ELLEN DRIVE SANITARY SEWER IMPROVEMENTS

SPRINGFIELD TOWNSHIP MUSKINGUM COUNTY, OHIO

REPLACEMENT OF AN EXISTING VARIABLE GRADE SANITARY SEWER
WITH GRAVITY SANITARY SEWER

NO.	DATE ISSUED	DESCRIPTION	SHEET NOS.
1	10/03/2024	ADDITIONAL MANHOLE (MH 13) AND PIPE RUN (MH 10 TO MH 13) TO SERVE TWO ADDITIONAL HOUSES	10
2	03/17/2025	CHANGE T/C OF MH 2, MH 3 AND MH 11 PER SURVEY FIELD VERIFICATION	7, 8, 10, 11
3	06/25/2025	CHANGE SEWER ALIGNMENT AND PROFILE FROM MH 4 TO MH 7 PLUS ADD MH 6A TO ELIMINATE CROSSING DRIVEWAYS	7 - 11
4	10/07/2025	UPDATED DEPICTION OF EXISTING WATERLINE IN PROFILE; EXTENDED MH 12 APPROXIMATELY 33.5 FT WEST OF PREVIOUS LOCATION	8, 10, 11

SHEET NAME:
PLAN SHEET (2)

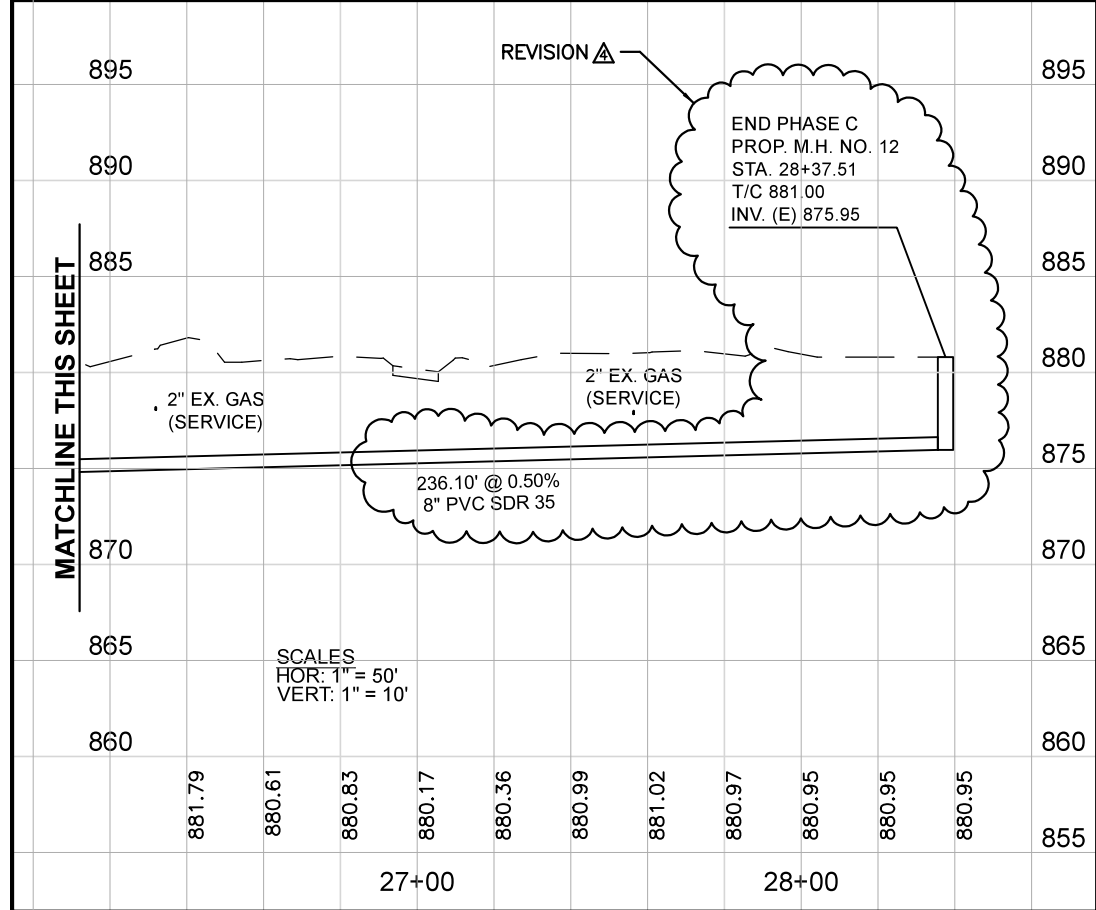
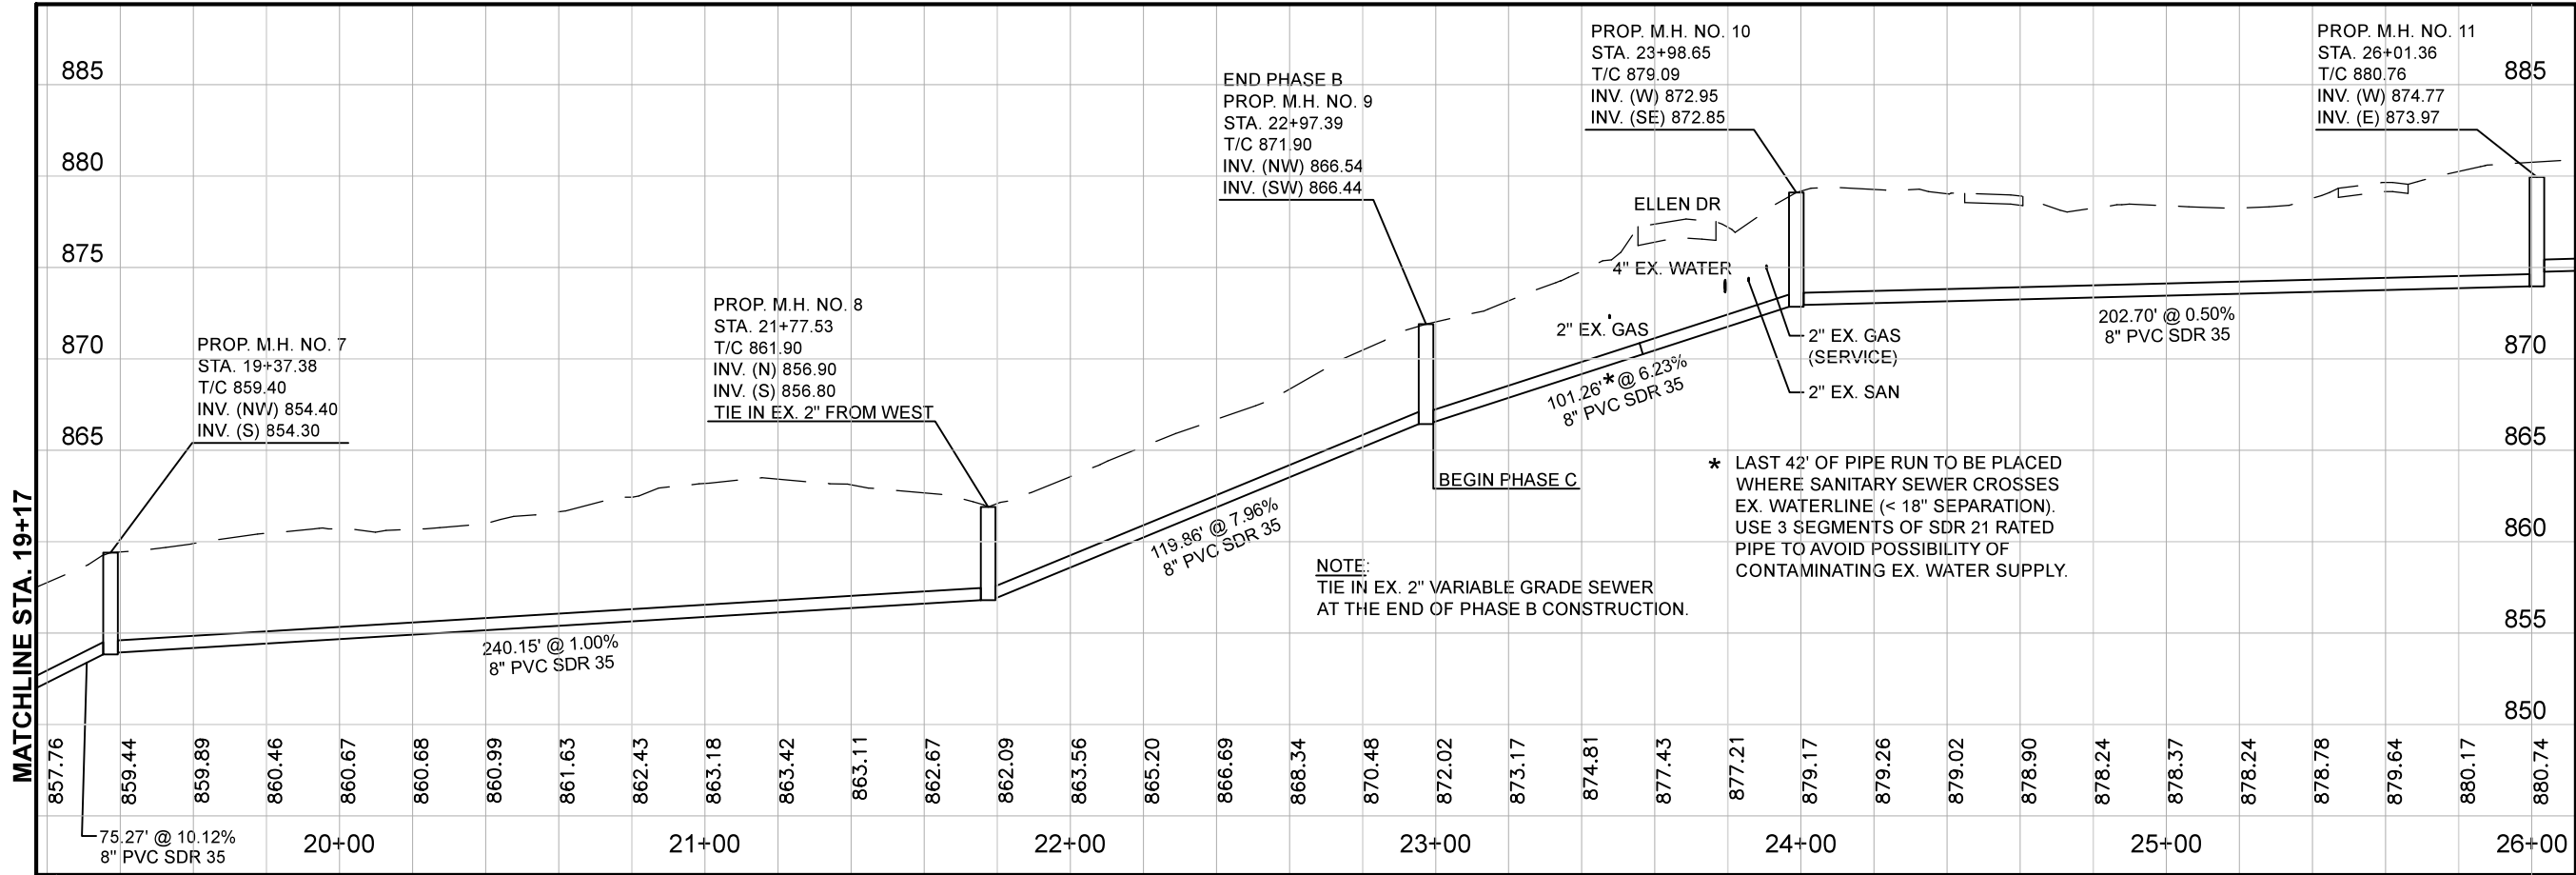
REVISION	REV. BY	DATE	DESCRIPTION
A	GJW	10/07/2025	EXTEND MH 12 APPROXIMATELY 33.5 FT WEST OF PREVIOUS LOCATION TO SERVE 1325 ELLEN DRIVE ALSO
